**ICC 500-2020 edition  
Public Input Agenda with  
Committee Votes and Public Comments  
based on input received  
on 2014 edition of the  
ICC 500 Standard**

**For February, 2020  
2<sup>nd</sup> Meeting – Teleconference**

## 2014 ICC 500-Standard Revision Proposals – Public Comments

**FIGURE 804.9.5.3**  
**SECTIONAL DOOR ASSEMBLIES**

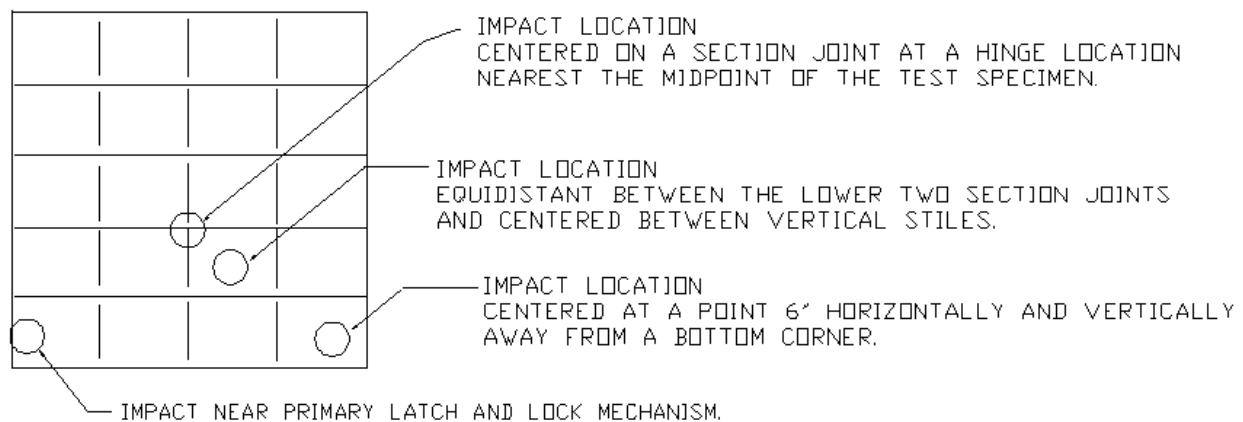
**804.9.5.3 Sectional door assemblies.** For sectional door assemblies, the door shall be impacted at a sectional joint nearing to the center of the door, within the lower two section joints and centered between two vertical stiles, at one bottom corner, and within 6 inches (152 mm) of the primary latches or operators as shown in Figure 804.9.5.3.

**FIGURE 804.9.7.2**  
**DOORS SUBJECT TO REBOUND IMPACT**

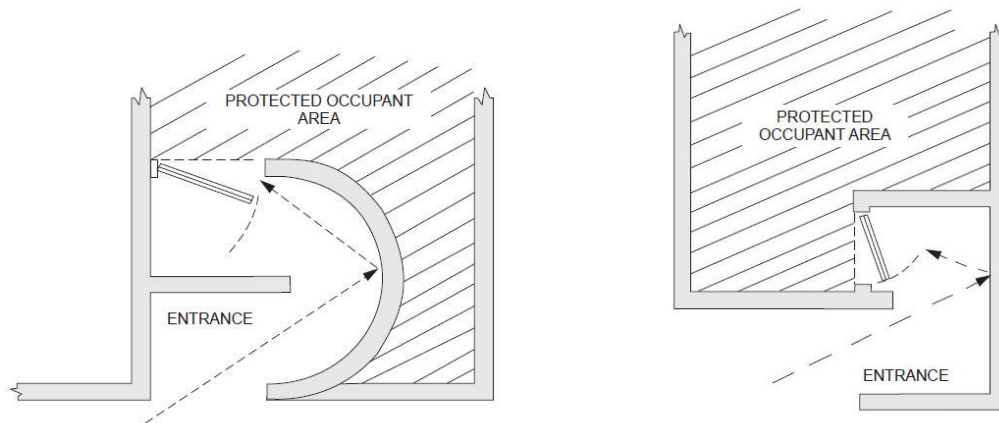
**804.9.7.2 Door subject to rebound impact.** Where the alcove or baffled entry system prevents a first impact of the design missile on the door but the door is subject to a rebounded impact of the design missile after it has impacted one surface meeting the requirements of Section 306.2 possible (~~see as detailed in~~ Figure 804.9.7.2), then a door assembly shall meet the wind load requirements of Section 304 and the debris impact requirements of Section 305 except that the missile shall be, at a minimum, a 9-pound sawn lumber 2 by 4 traveling at 50 feet per second (15.2 m/s). Entry systems having doors that are protected from the initial and first rebounded impacts of debris shall comply with the requirements of Section 804.9.7.1.

**Reason:** The way figures are referenced is not consistent and does not make the figure part of the requirement. Using “as detailed in” or “as shown in” would be consistent with the figure references of impact location in 804.9. In Items 1, 2 and 3 of Section 804.9.7, “Examples of this type of system are shown in Figure...” is not needed. As written it is editorials information, not a requirement; and the figures are referenced in each of the referenced sections.

FIGURE 804.9.7.3  
DOORS SUBJECT TO FIRST IMPACT

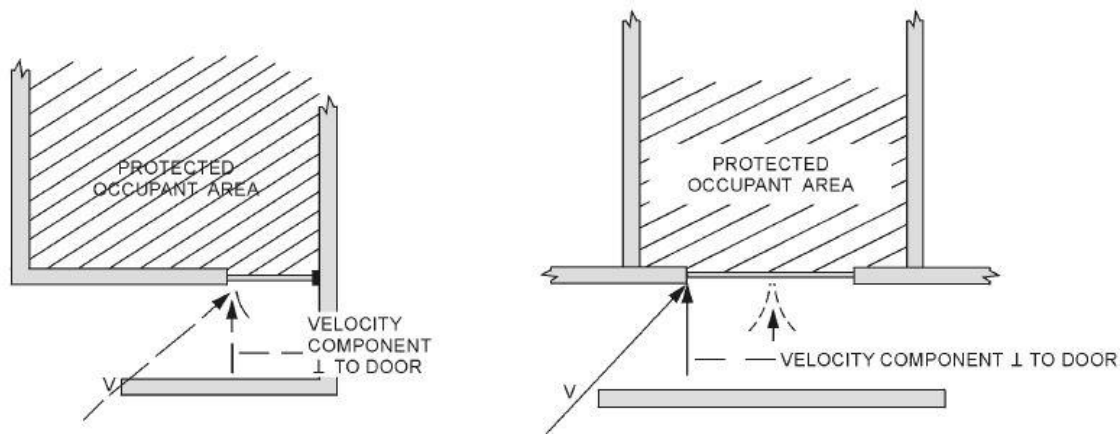
**804.9.7.3 Door subject to first impact.** If a first-strike angle missile impact on the door is possible (~~see as detailed in~~ [Figure 804.9.7.3](#)), then the door is deemed suitable if the door assembly meets the wind load requirements of Section 304 and the door assembly meets one of the following debris impact criteria:
